# 102<sup>nd</sup> STREET LANDFILL SITE

## FINAL CLOSE OUT REPORT

### VOLUME 8

RE: 102<sup>nd</sup> Street Landfill Site, Niagara Falls, NY  
Final Closeout Report and Remedial Action Report, Response to EPA comments dated July 11, 2000  
Landfill Residuals, Perimeter Soils, Shallow Groundwater,  
Non-Aqueous Phase Liquids (NAPL), and Embayment Sediments  
Operable Units 1 & 2

OXYGEN/OIL -- REMEDIAL DESIGN  
102nd STREET LANDFILL SITE  
NIAGARA FALLS, NEW YORK  
APL SYSTEM FLOW DIAGRAM

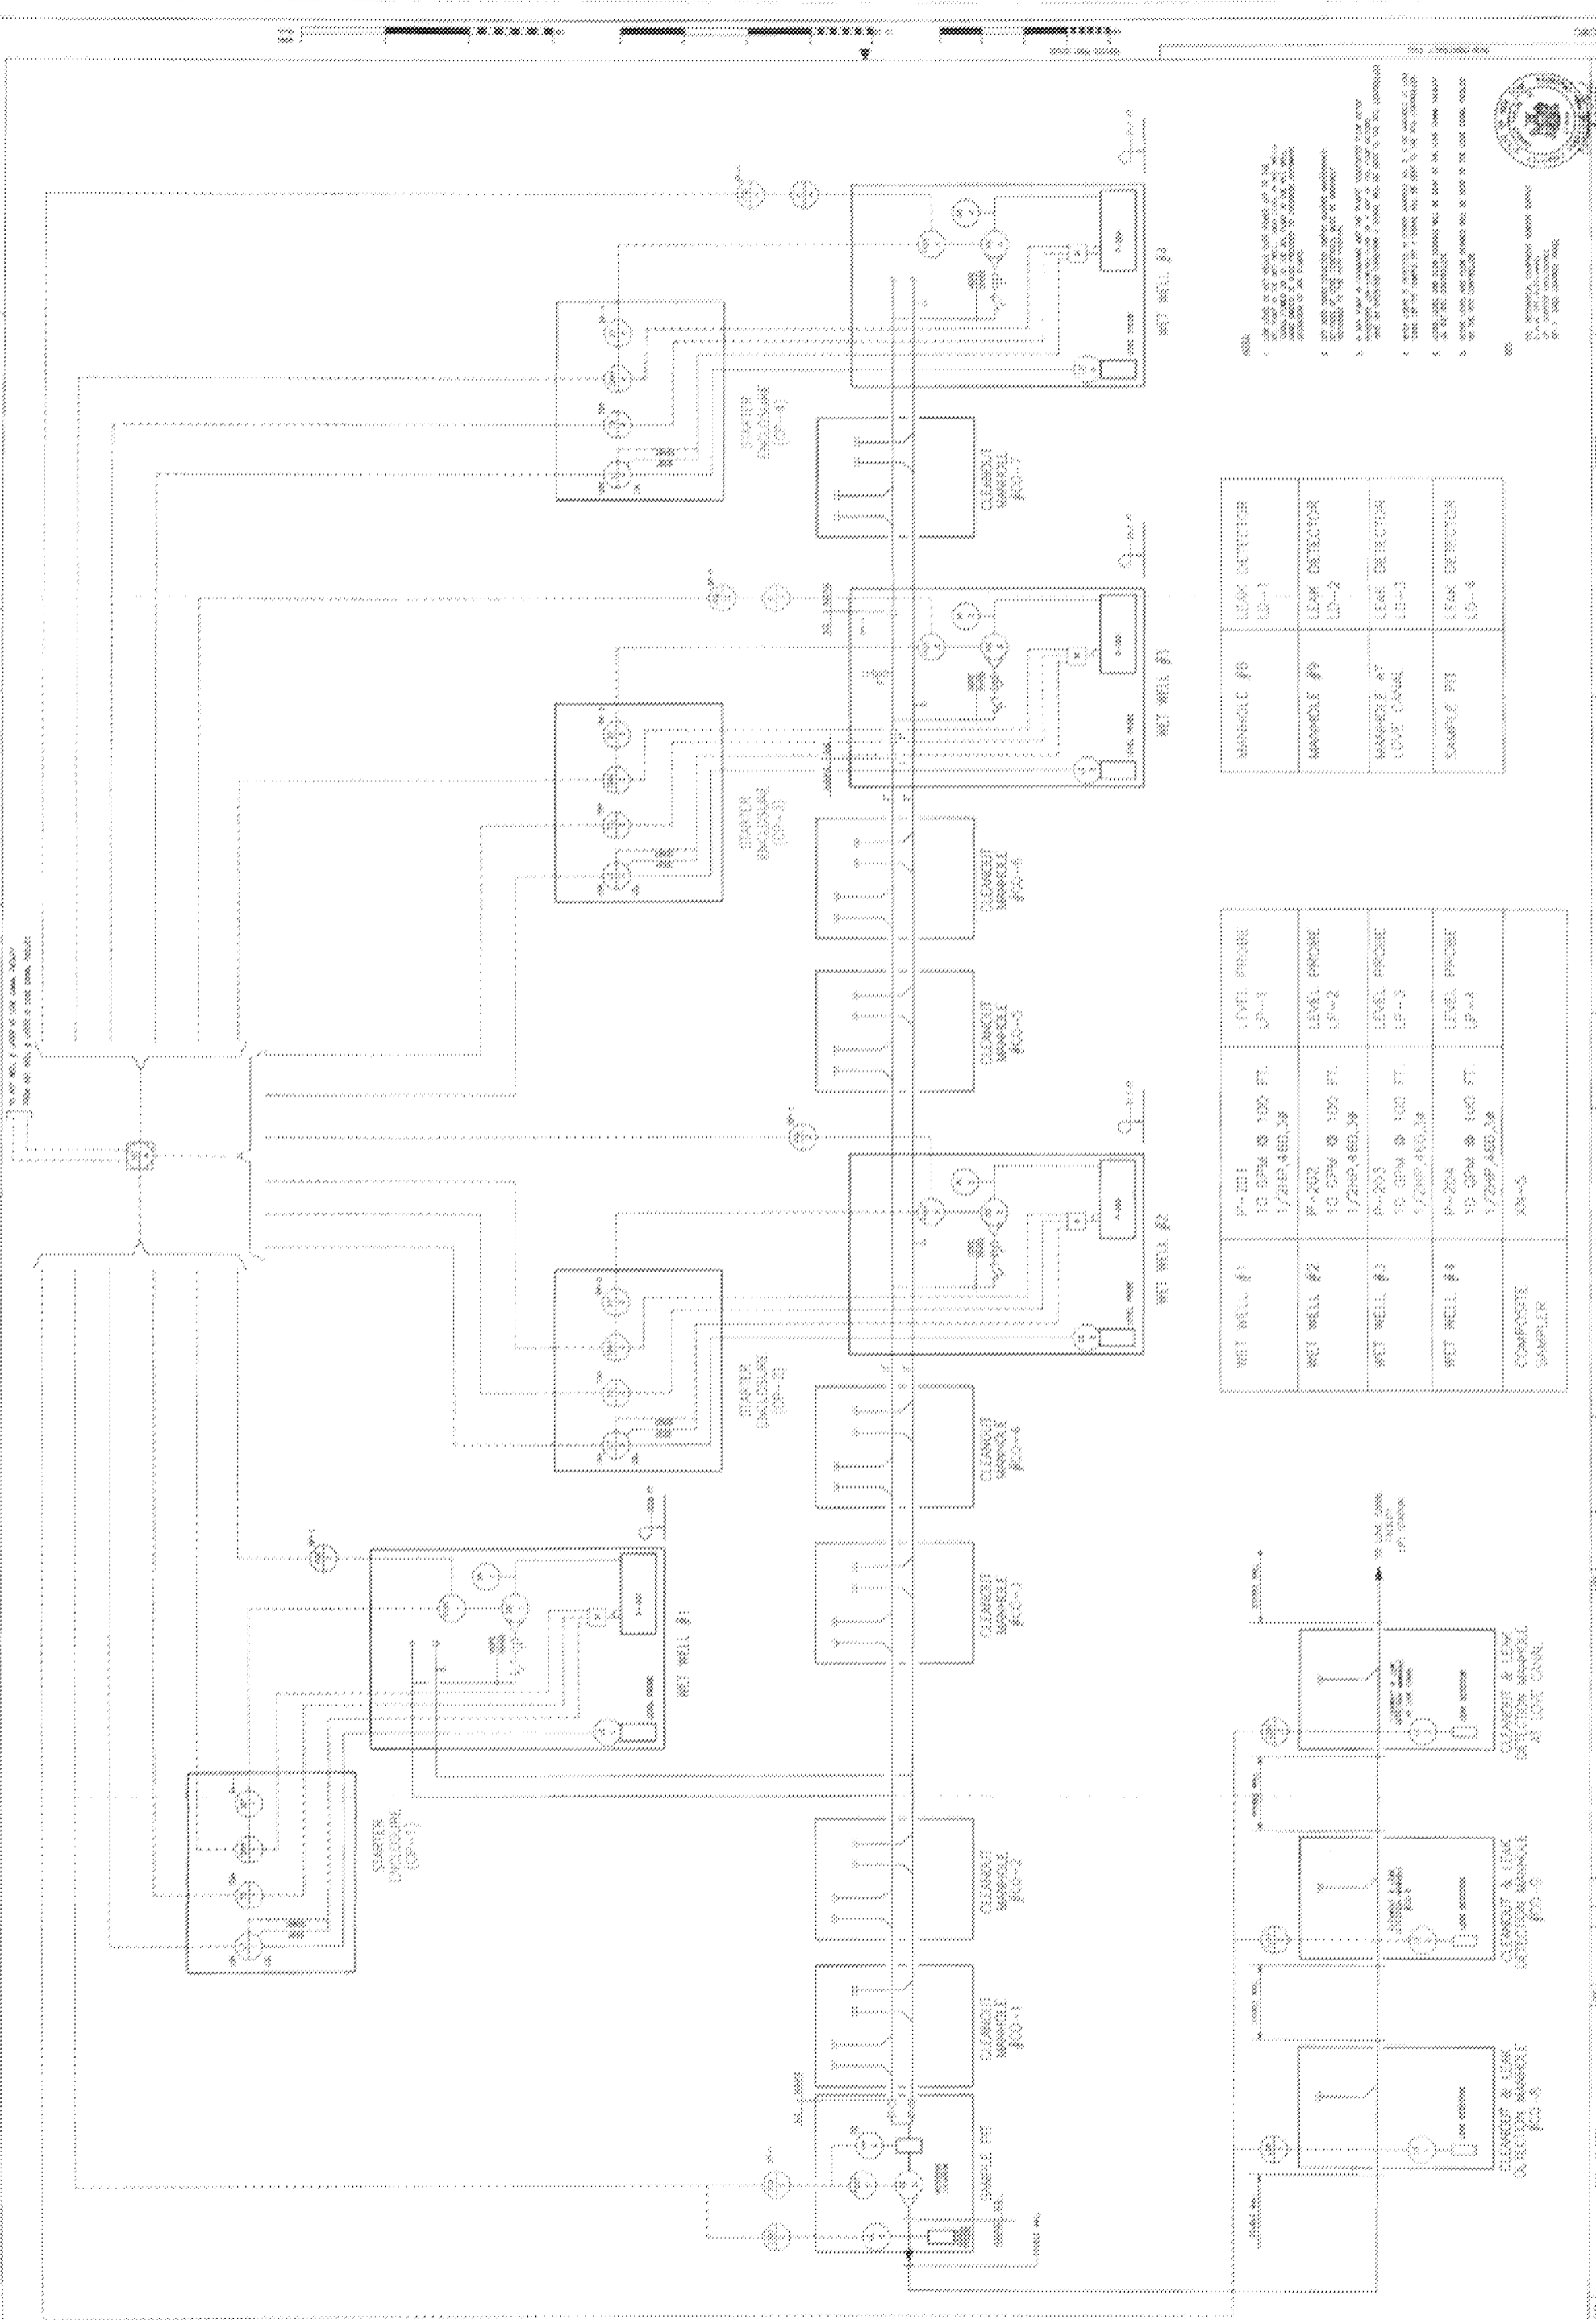
- 3.- As-Built Drawings:

Drawings 594000-25J-02 (P&ID APL) and 23594010-SK-270-107 (INST. BLOCK)

These drawings are acceptable only as schematic drawings. Detailed as-built electrical drawings shall also be provided.

**List of Drawings (Modified Additions for detailed "as-built" Electrical Drawings and  
Modified P&IDs per Comment 3)**
